Transmitted by the expert from Japan

PROPOSAL FOR DRAFT CORRIGENDUM TO REGULATION No. 12
(STEERING MECHANISM)

Annex 4-Appendix, amend to read

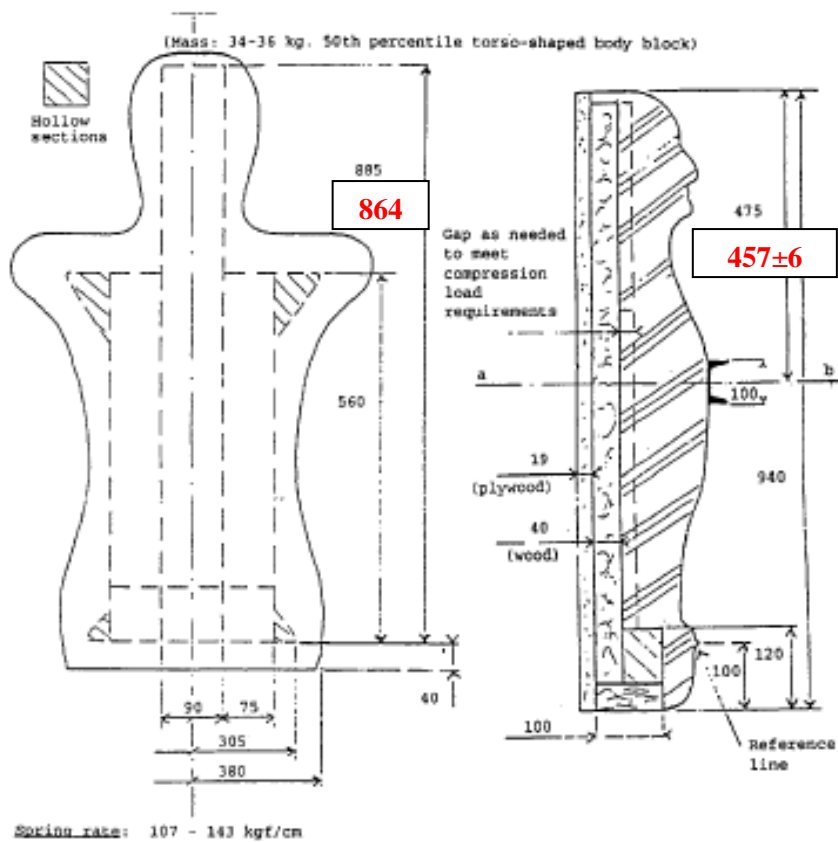
475 **457±6**

885 **864**

The dimension of Body Block is internationally based on the SAE standard J944 JUN80 (See attached document). However, the dimensions for the above two parts specified in SAE J944 JUN80 are different between “inch” and “centimeter” units. These are clerical errors in unit conversion from “inch” to “centimeters”, and these dimensions should be read as $18\pm 0.25\text{inch} = 47.5\pm 0.63\text{cm}$ **457±6mm** and $34\text{inch} = 88.4\text{cm}$ **864mm** respectively. Since ECE R12 incorporates the dimensions misconverted in SAE standard, therefore those errors should be corrected.
